Addendum No. 2

Temporary Shelters Project
RFP No. 2001-DD

January 24, 2020

Shelter Cabin Specifications for Addendum No. 2

TEMPORARY HOMELESS SHELTER SAMPLE CABIN LAYOUT

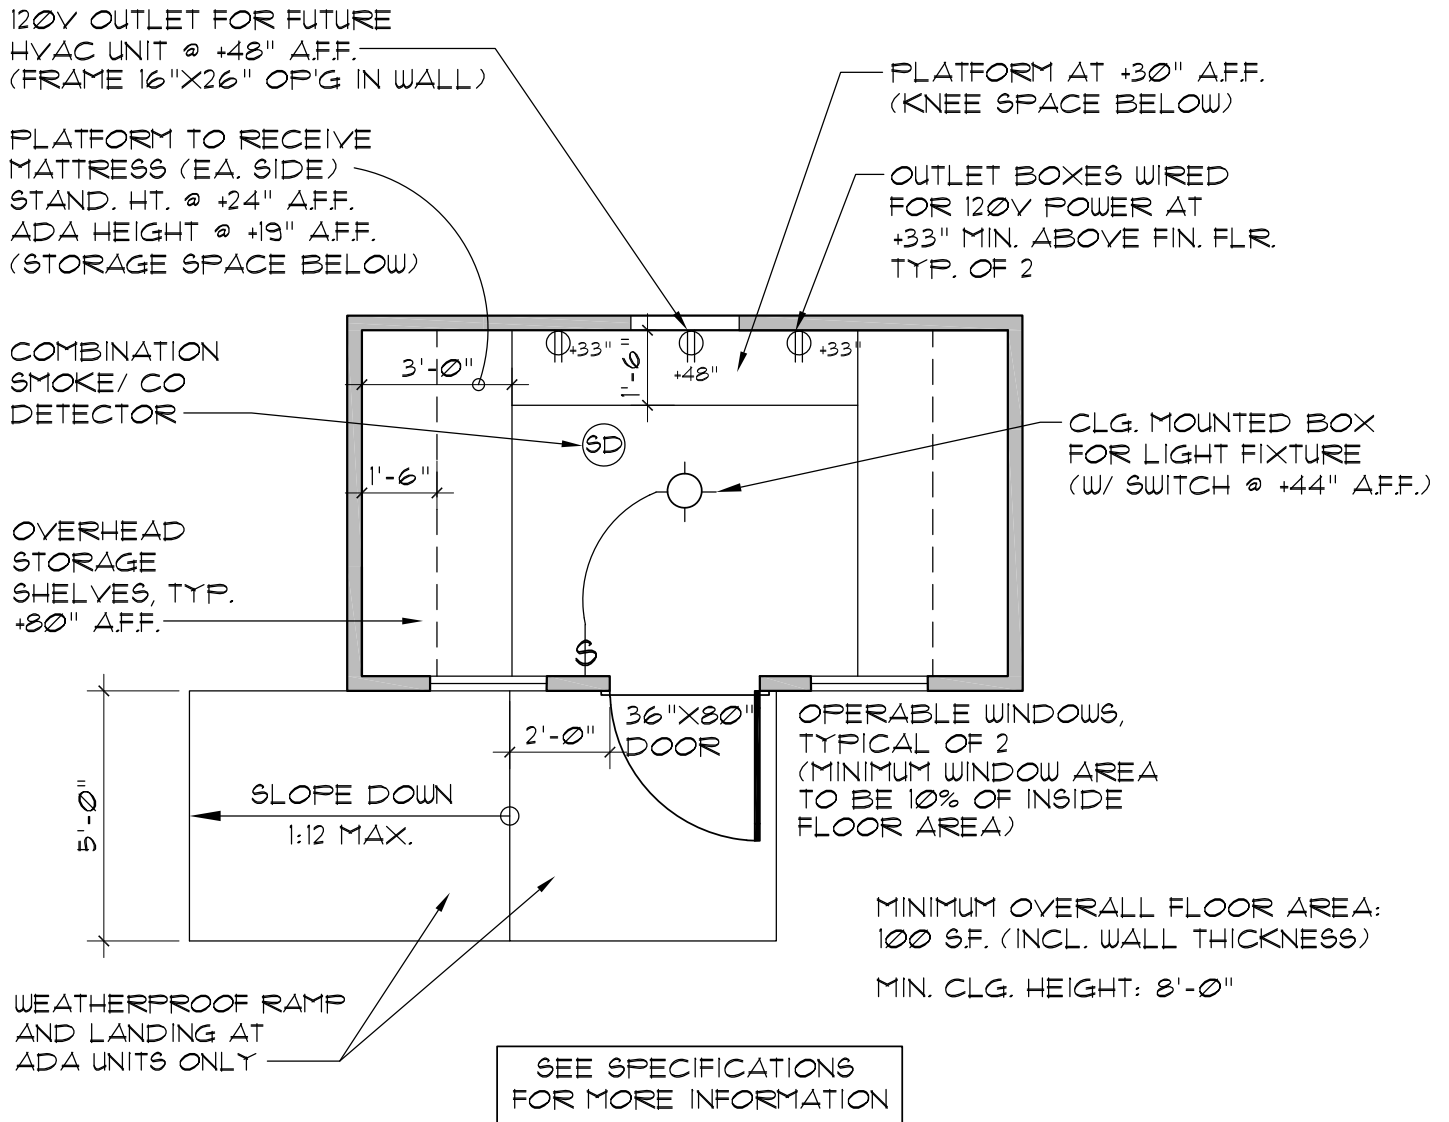
INSERT: Attachment A – Addendum No. 2 - Temporary Homeless Shelter Sample Cabin Layout

- i. See Sample Cabin Layout attached for location
 - b. One 120V wired ceiling box (15 amp with minimum 14/2 wiring)
 - i. See Sample Cabin Layout attached for location

- i. See Sample Cabin Layout attached for location
 - e. Shall have provisions for connection to the grid (SMUD). Electrical homeruns shall terminate in a metal outlet box mounted on the exterior of the cabin. Agency will provide subpanel and utility connections under a separate contract.

3. Door (see plan for sample location)
 - a. One 6-panel 36"x80" insulated residential door (outswing). Preferably fiberglass skinned
 - b. Lever style entry hardware (lockable)

- c. Landing and ramp at ADA units (see plan for sample location)
4. Windows
 - a. Two operable windows (one on each side of entry door) with screens
5. Sleeping arrangements
